MOST Project -AD A 051402 service test reports Evaluation of Modified Preproduction Model of AD NO. 3690-Meter Surface-Vessel Bathythermograph OC-6/S ENGINEERING DIVISION G.D. SHIPWAY MAR 16 1978 SUBIT U. S. NAVY ELECTRONICS LABORATORY, SAN DIEGO, CALIFORNIA A BUREAU OF SHIPS LABORATORY 2333 DISTRIBUTION STATEMENT A Approved for public release; Distribution Unlimited

Conduct engineering tests and evaluation of modified 3000-Meter Surface Vessel Bathythermograph OC-6/S to determine acceptability for Naval use.

FIG. 4

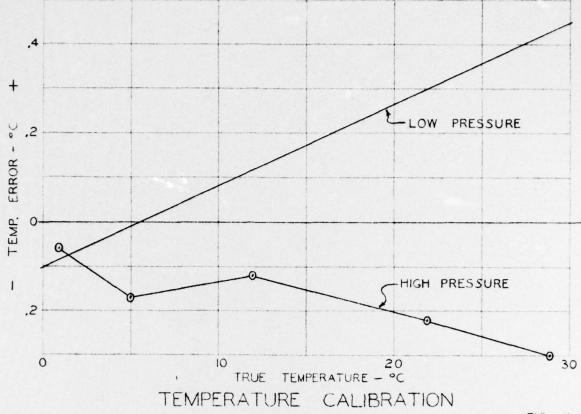
The upper temperature calibration curve, shown in figure 4, is the line drawn through the middle of all the test points taken at low pressure. All of the low pressure test points were within 0.1°C of this line. The lower curve shows the test points taken at high pressure. There was no change in calibration after exposure to overtemperature and overpressure, nor was there any appreciable temperature hysteresis.

1. Improve the temperature calibration.
